**BEFORE THE INDEPENDENT HEARING PANEL APPOINTED BY THE
QUEENSTOWN LAKES DISTRICT COUNCIL**

**JOINT STATEMENT OF URBAN DESIGN & TRANSPORT EXPERTS IN
RELATION TO TE PŪTAHI LADIES MILE PLAN VARIATION**

DATED 24 NOVEMBER 2023

SH6 (20m Amenity Access Area)

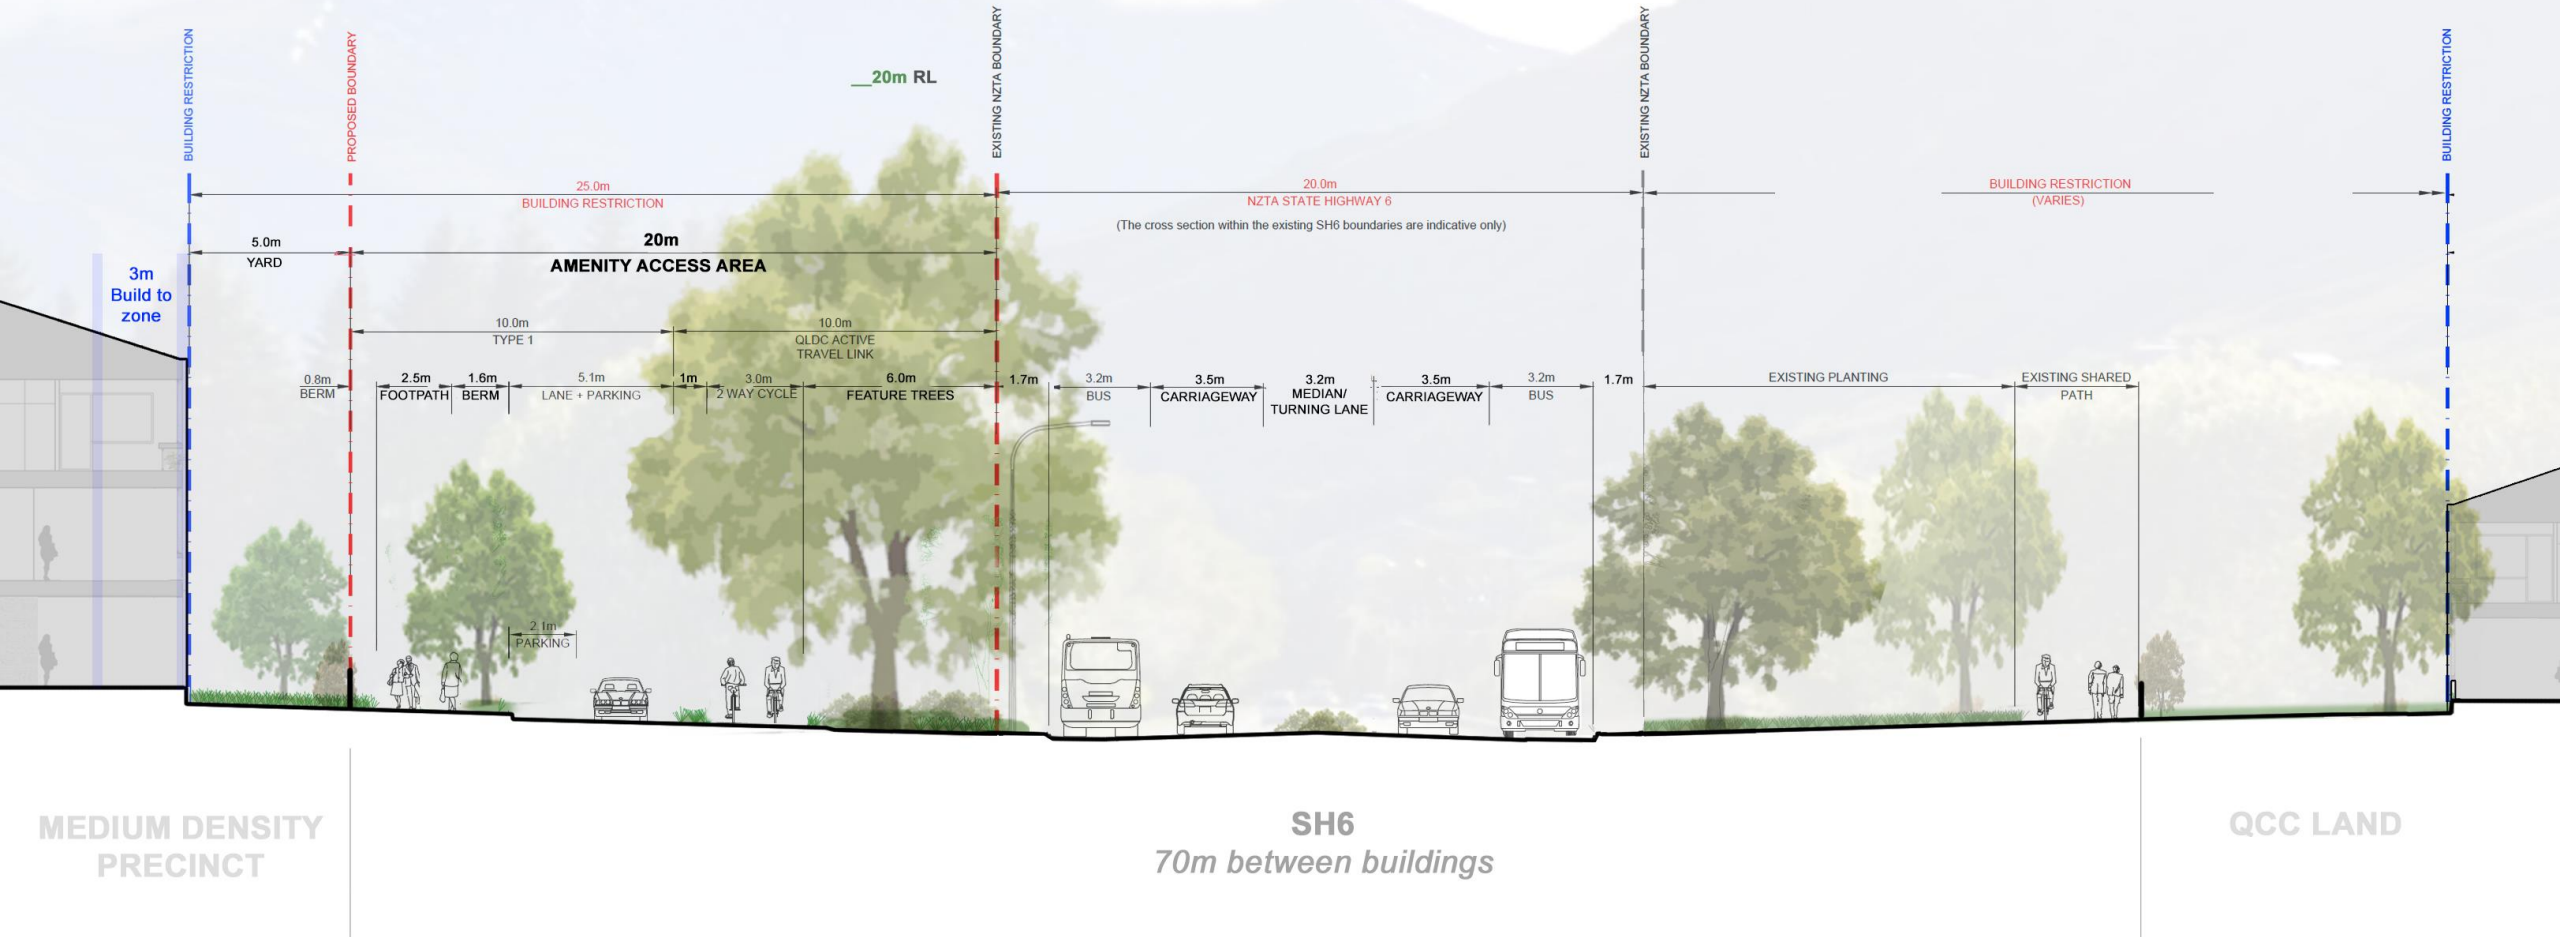
| | | <p>Council Option 1 - SH6 (20m Amenity Access Area):</p> <ul style="list-style-type: none">• 70m between building faces (no change on south side)• 20m SH6 Road Reserve with 4 lanes (i.e. one travel lane and one bus lane in each direction) and median strip• 20m Amenity Access Area on north side, including slip lane and car parking (with second footpath removed) with 6m feature tree width.• 25m Building Restriction distance with 5m road boundary setback with 3m 'build to zone' <p>Council Option 2 - SH6 (18m Amenity Access Area):</p> <ul style="list-style-type: none">• 65m between building faces (no change on south side)• 20m SH6 Road Reserve with 4 lanes (i.e. one travel lane and one bus lane in each direction) and median strip• Reduced 18m Amenity Access Area on north side, removing slip lane and increasing feature tree (8.4m) and front berm (3.6m) widths.• Reduced the 25m Building Restriction distance to 20m with 2m road boundary setback with 3m 'build to zone'. <p>No changes were proposed or sought to the south side (25m) area.</p> |

SH6 (18m Amenity Access Area)

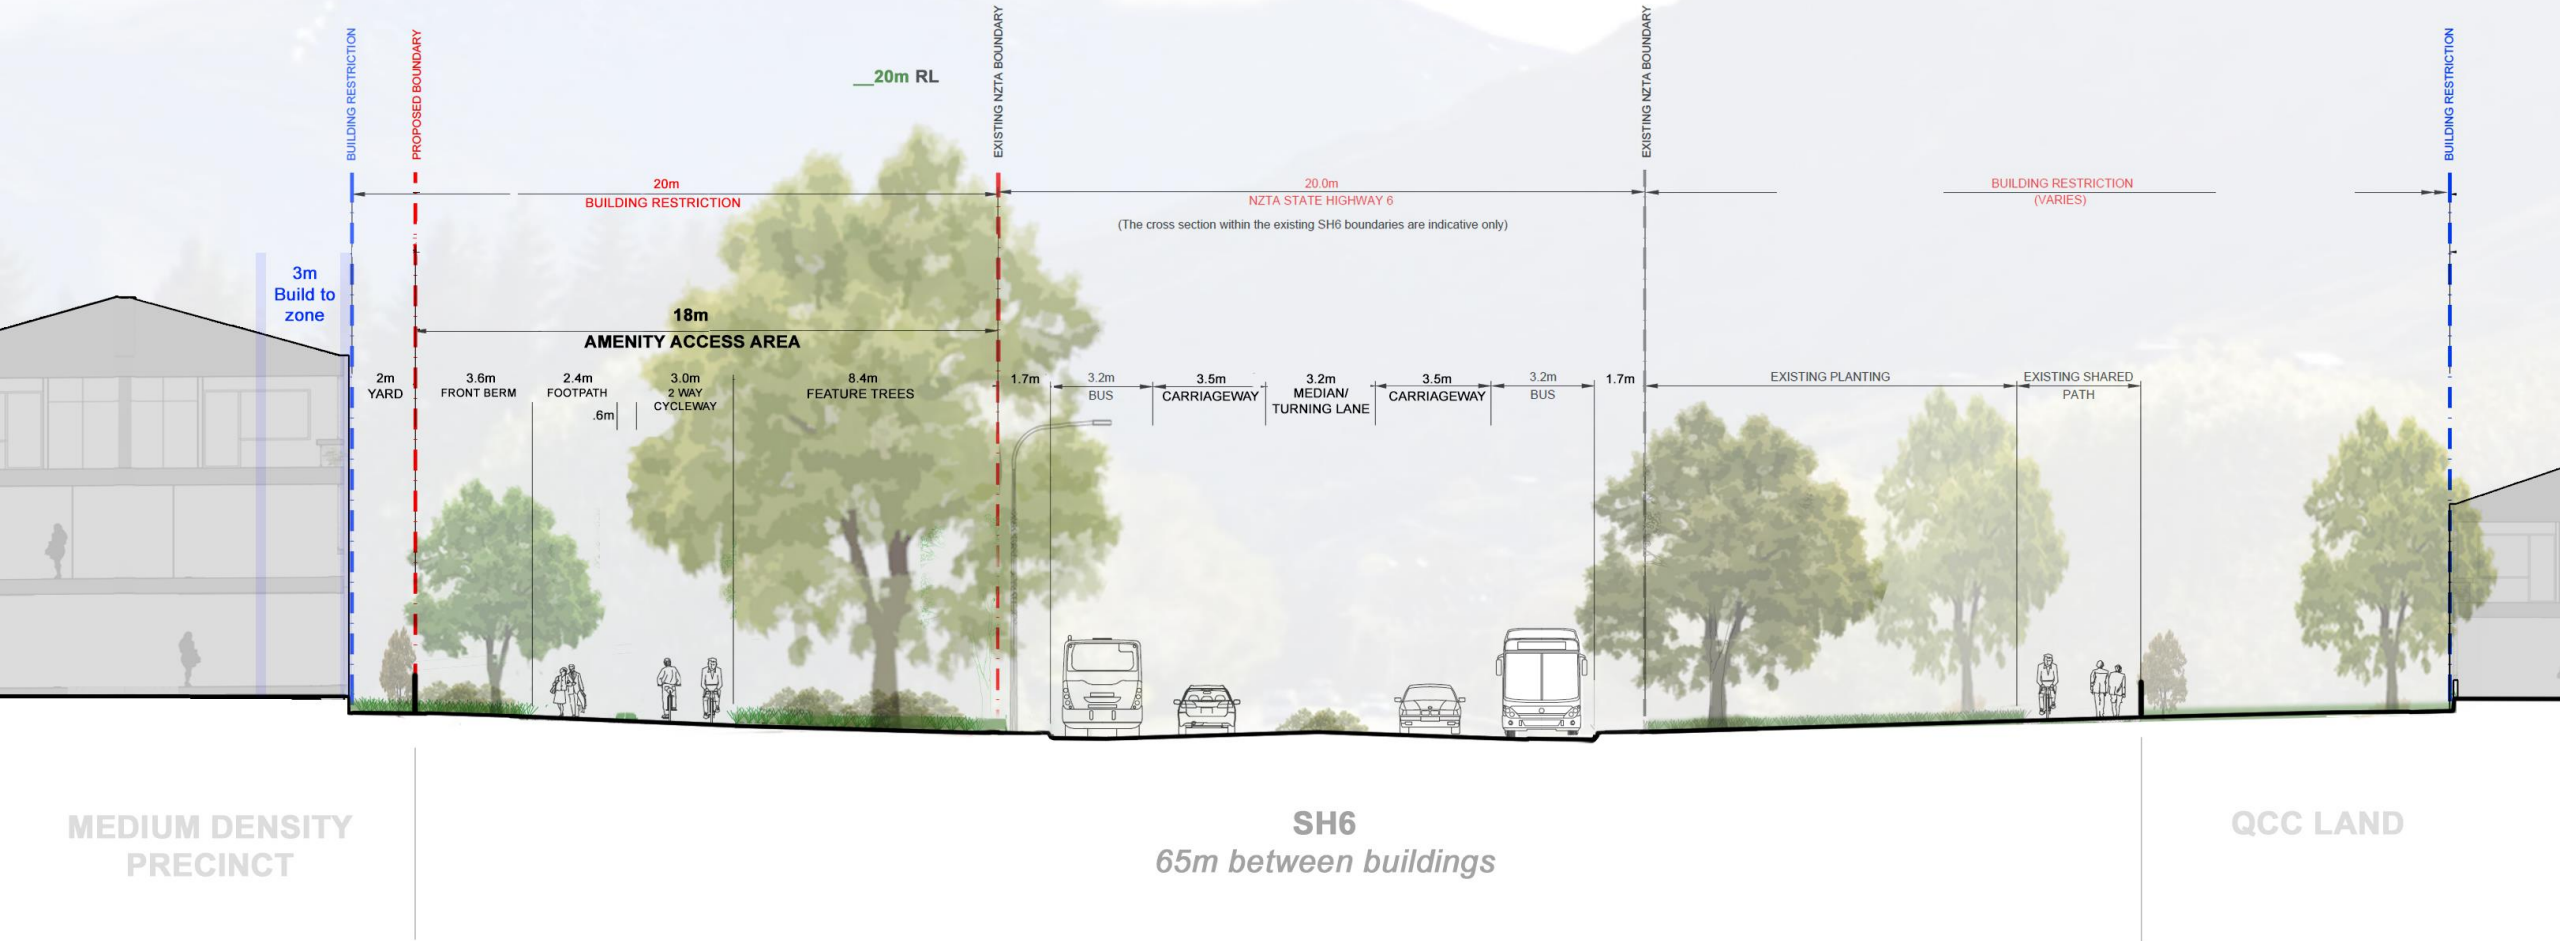
| | | <ul style="list-style-type: none"> • Detail that intersection upgrade requirements would be accommodated on south side. <p>No agreement was reached as to what cross section(s) were preferable between the Council Option 2 - SH6 (18m Amenity Access Area) and Alternate Concepts by submitters.</p> <p>Mr David Compton-Moen was not able to attend the second conferencing, but indicated that the cross section should be as efficient and small as possible to create a relationship between the northern and southern sides.</p> |

SH6 Ladies Mile Cross Sections

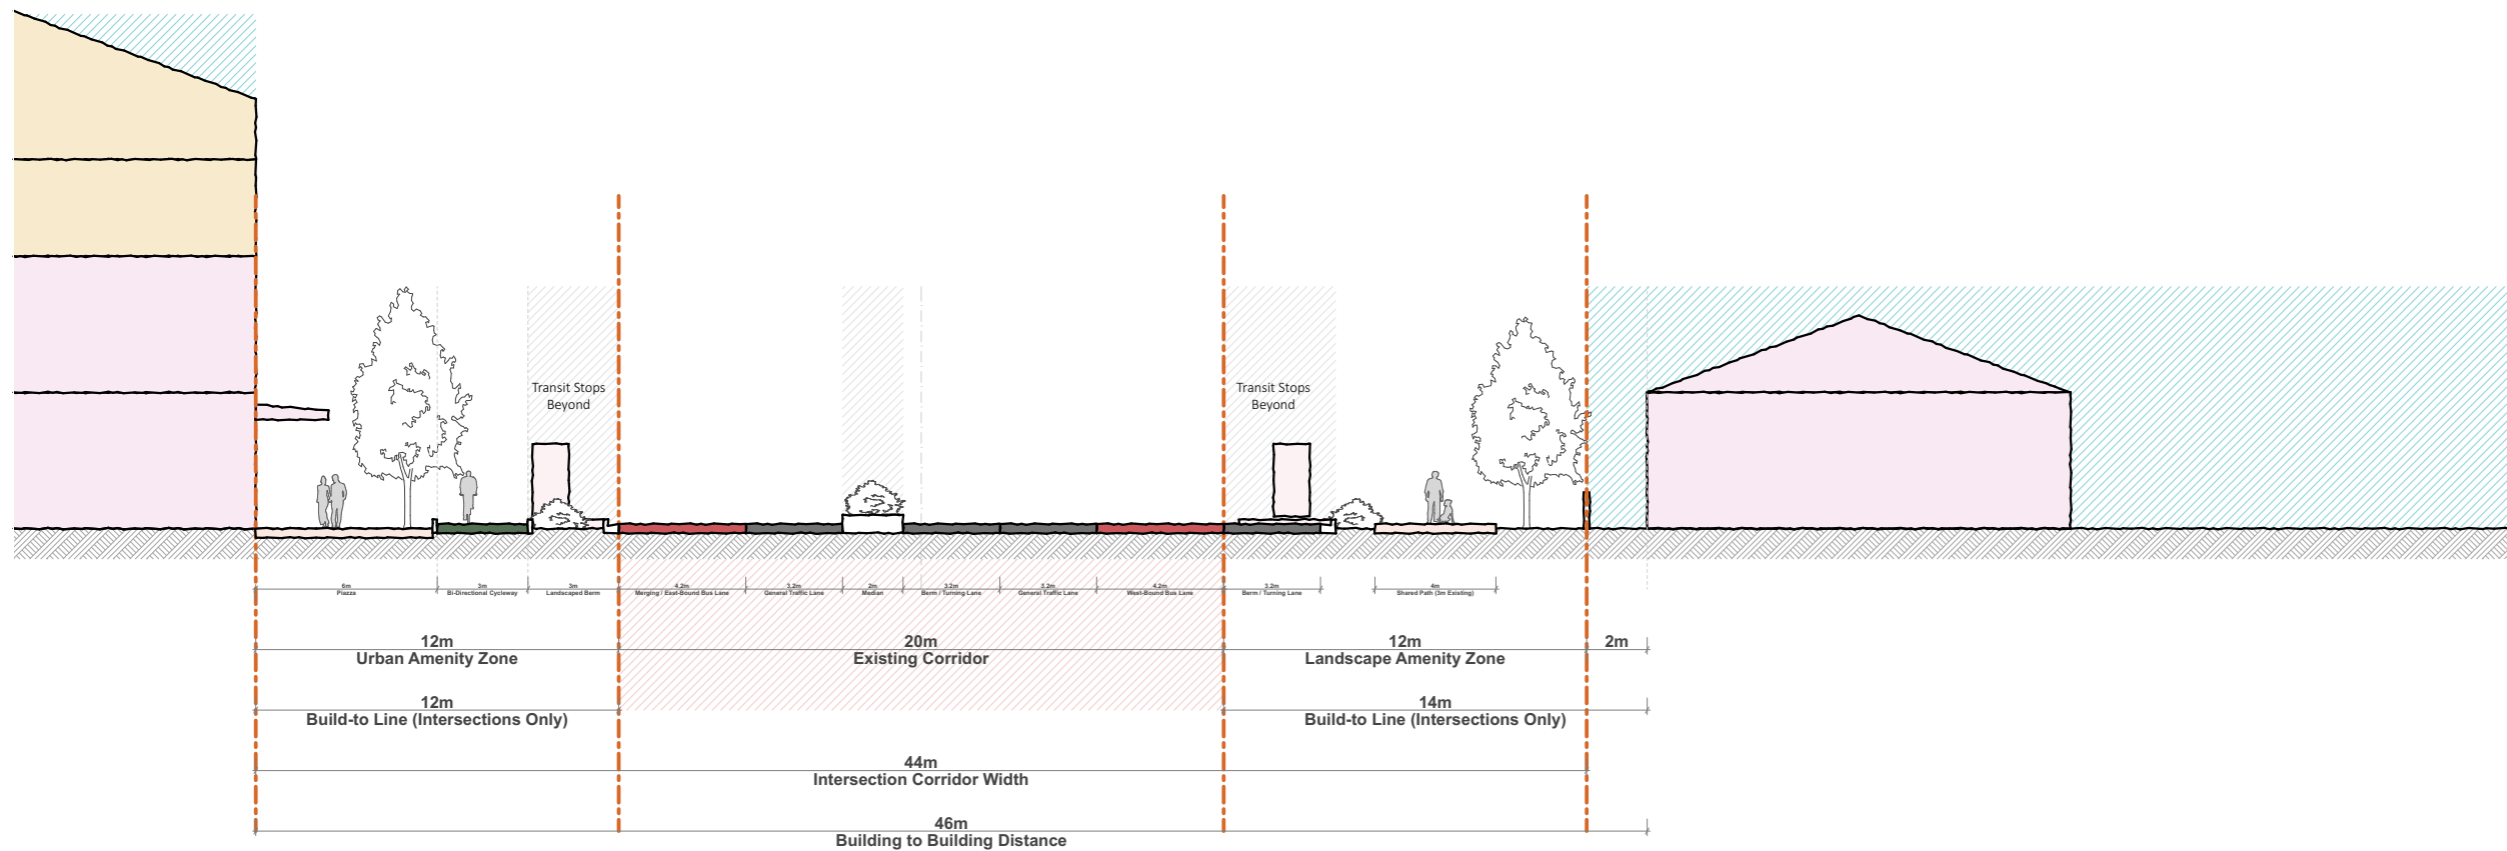
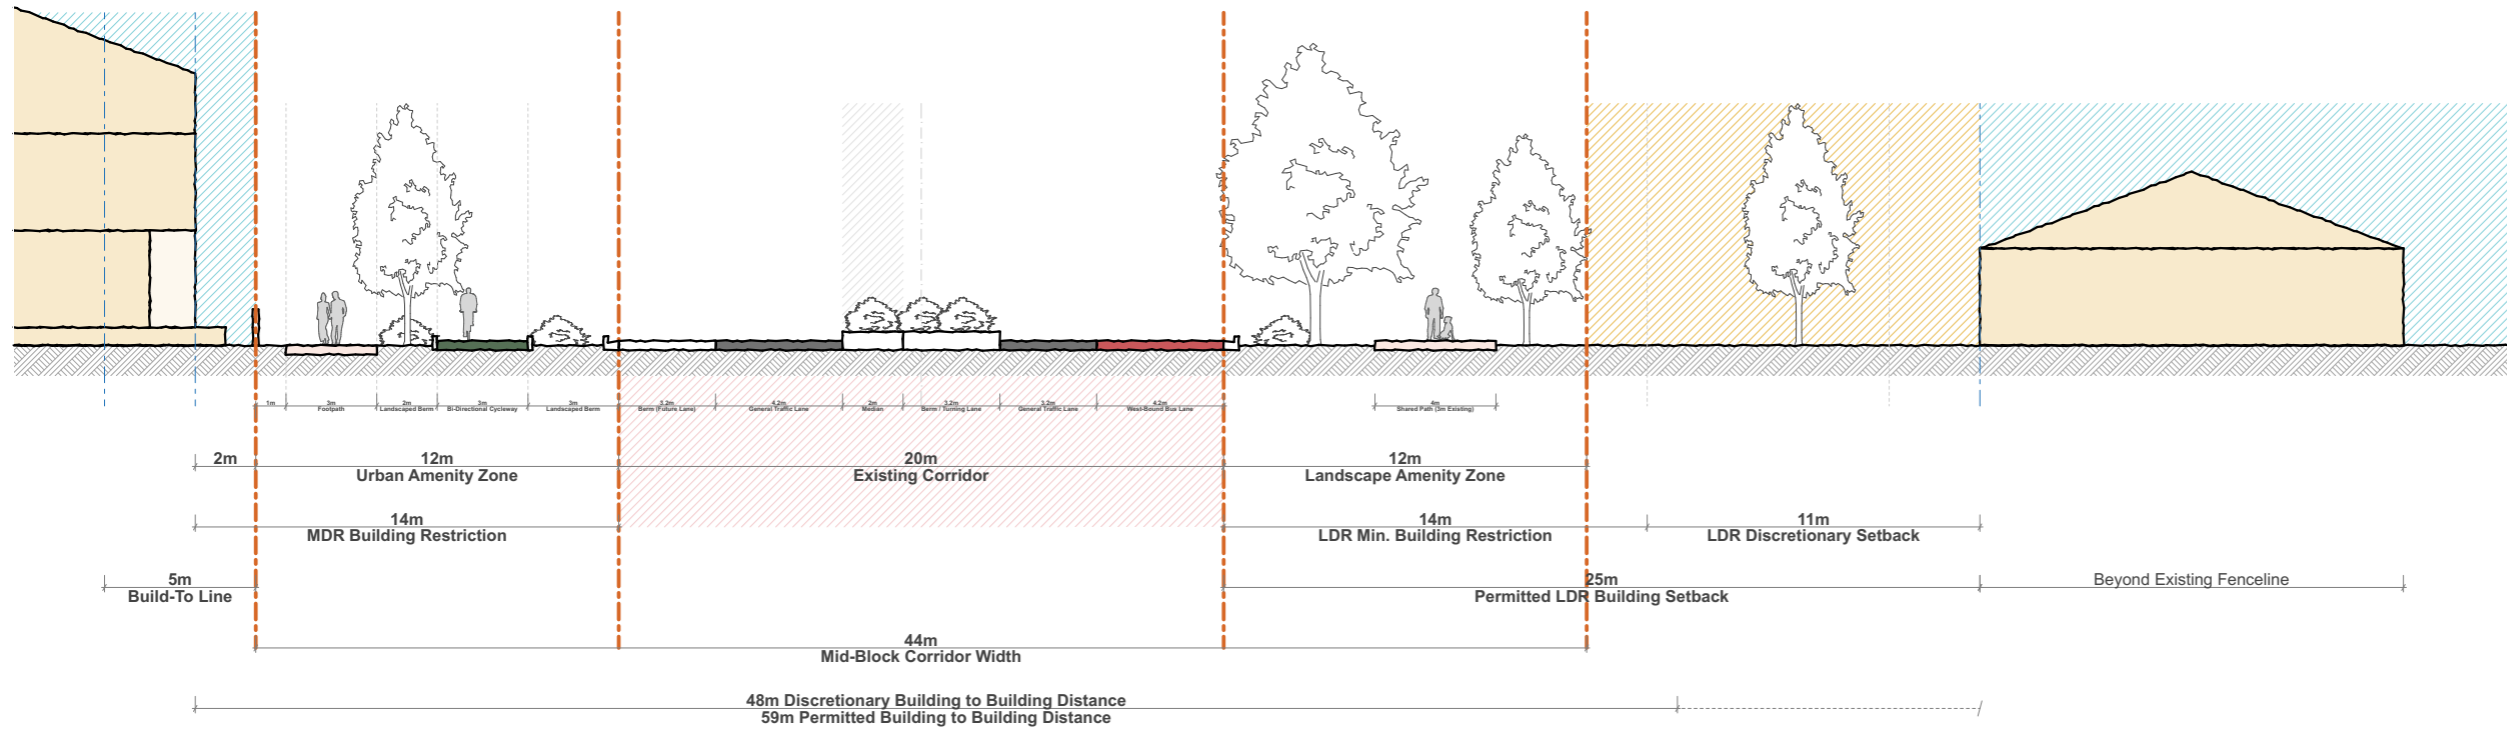
| | | <p><u>Alternate Cross Sections by Submitter Experts</u></p> <p>During the second conferencing, Mr Weir, Mr Rossouw (assisting Mr Weir) and Mr Bartlett presented three alternative options representing different conditions along the SH6 corridor (i.e. QCC Clubhouse mid-block, typical mid-block and urban node) in Attachment C.</p> <p>Both options illustrate 20m SH6 Road Reserve with 4 lanes and landscaped median strip.</p> <p>The comparable typical mid-block cross section, includes:</p> <ul style="list-style-type: none">• 60m between building faces (no change on south side)• Reduced 12m Amenity Access Area, removing slip lane with two 3m tree berms.• Reduced 14m Building Restriction distance with 2m road boundary setback. <p>The urban node (signalised intersections) cross section, includes:</p> <ul style="list-style-type: none">• 57m between building faces• Reduced 12m 'Urban Amenity' Area on north side with bus stop and piazza.• No Building Restriction distance or road boundary setback. |
